Re: Response to Informal Conference Technical Analysis dated March 26, 2003,
Hiawatha Mine Complex, C/7007/011-AM02B-2

Response To Technical Analysis Dated March 26, 2003

Title: Hydrology Update (AM02B-2)

PLATE 7-2

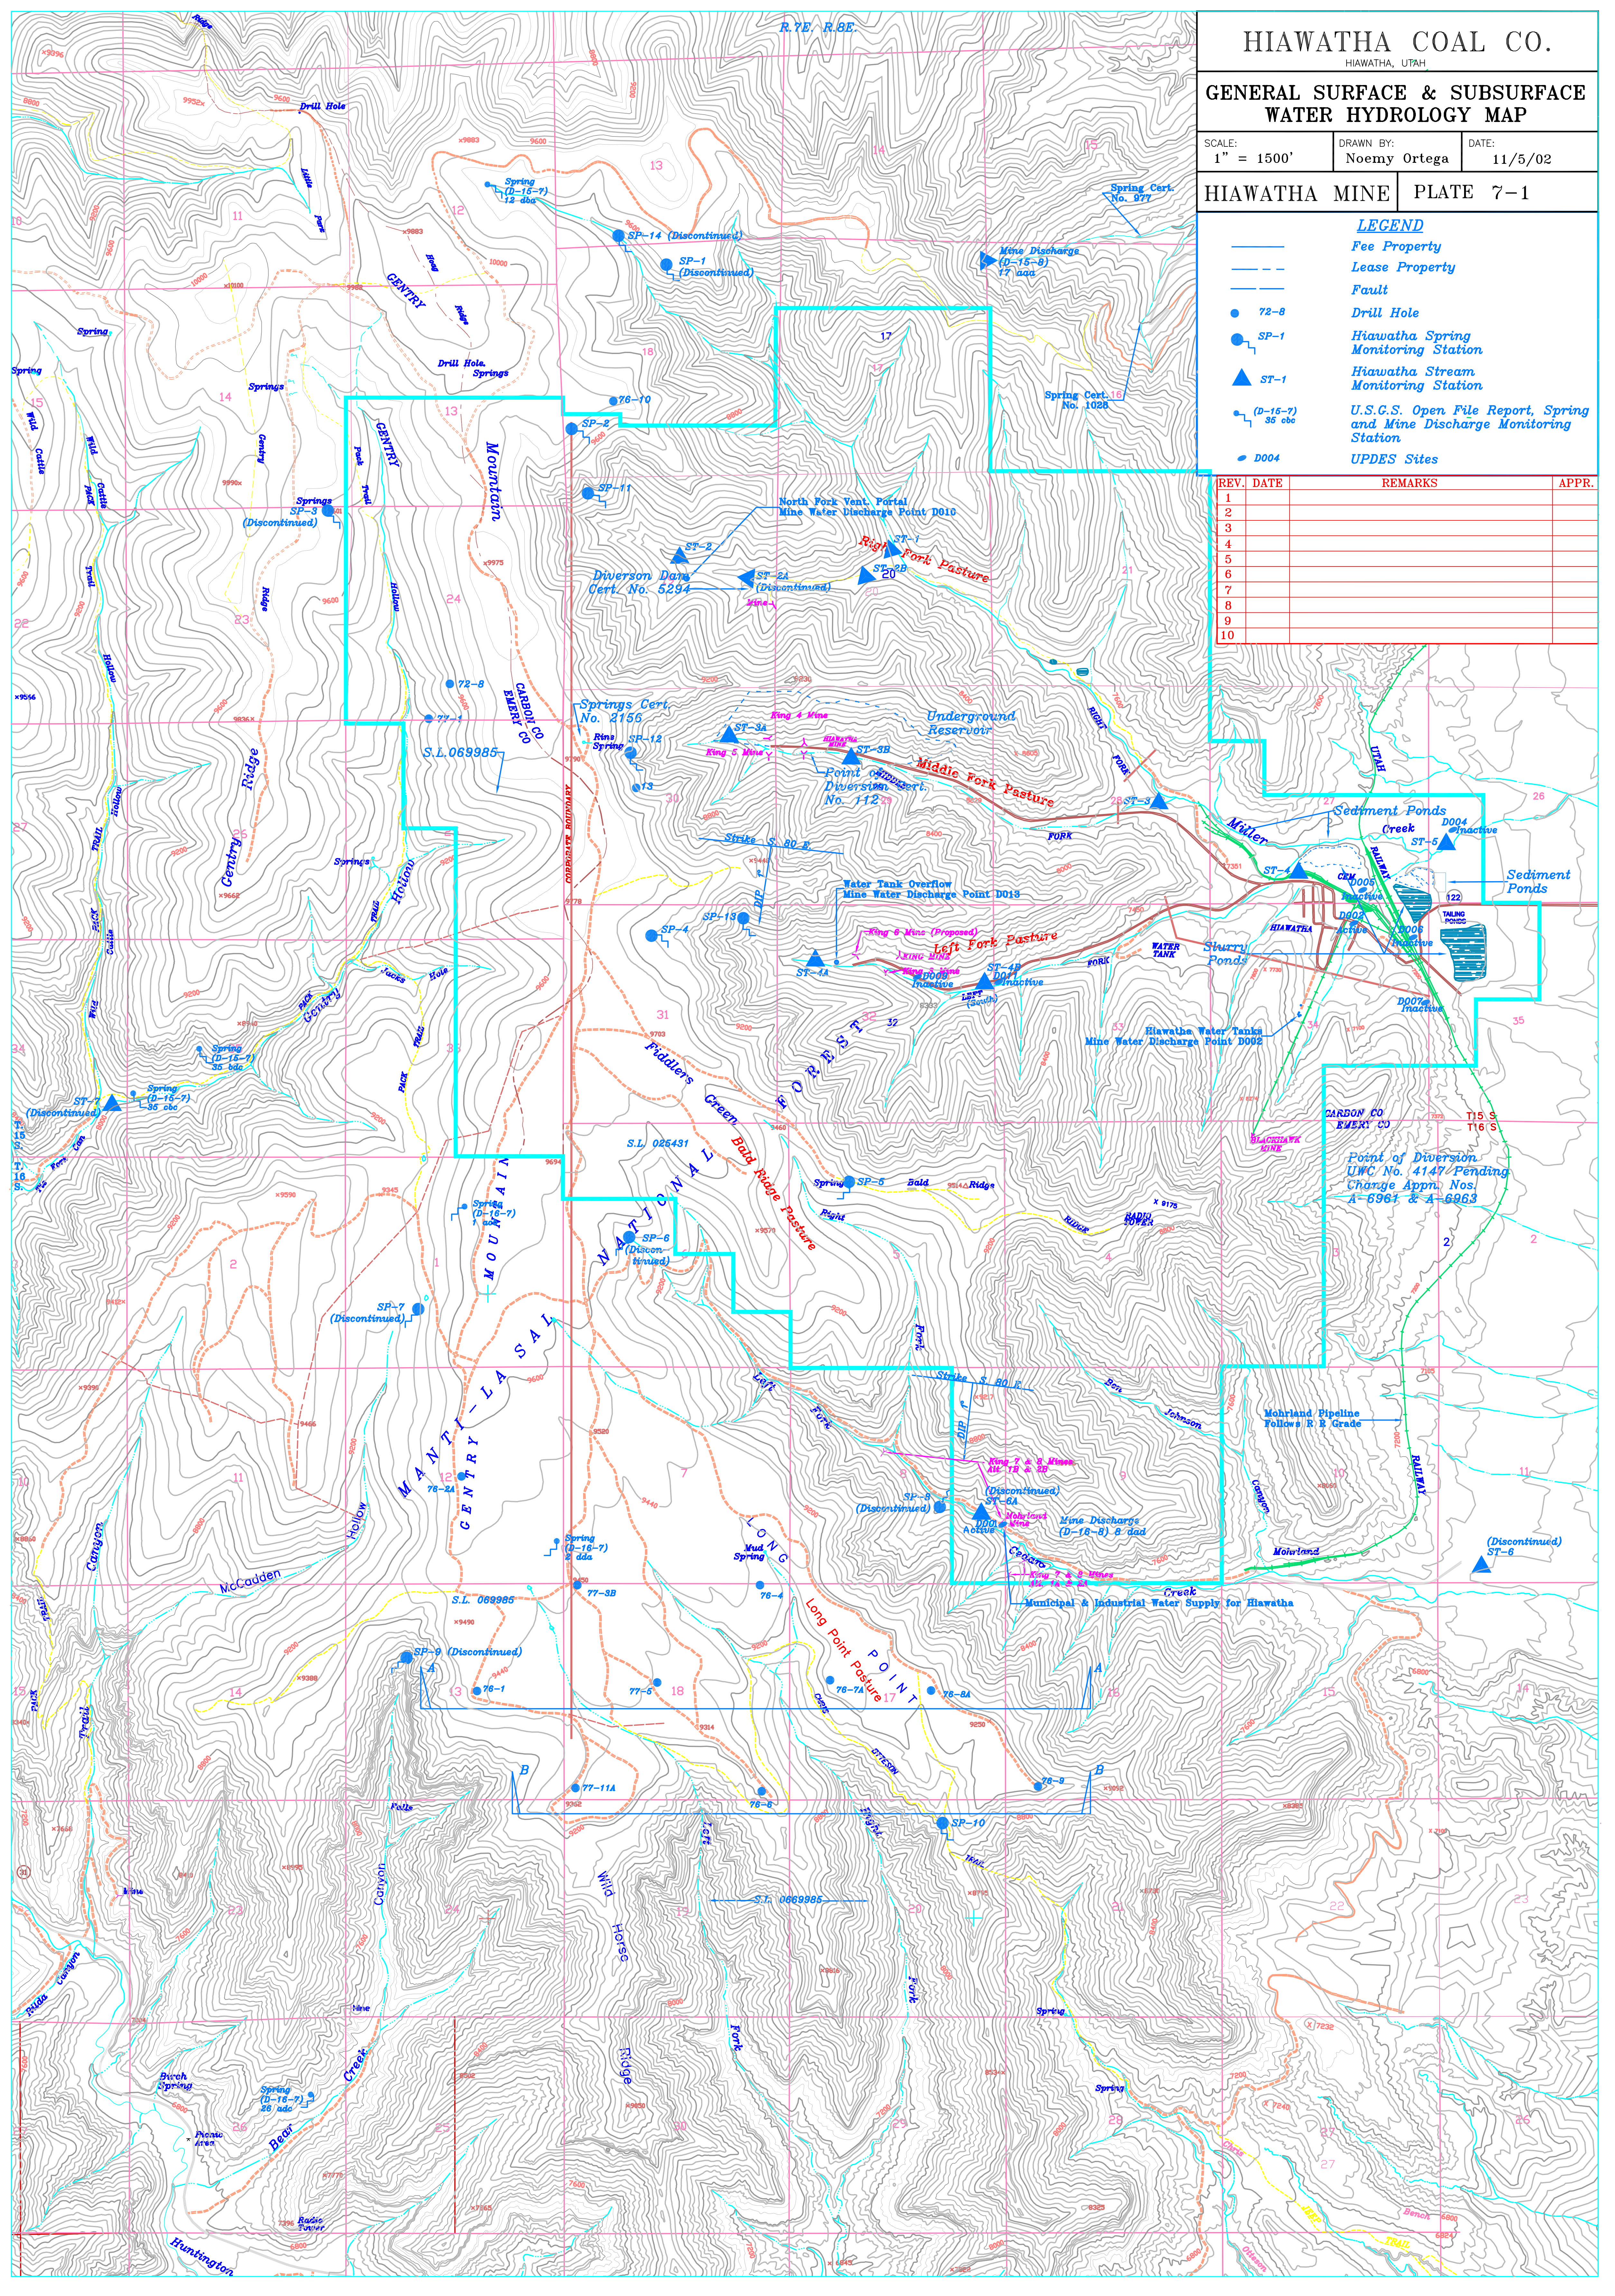
The requested changes have been made to Exhibit 7-2.
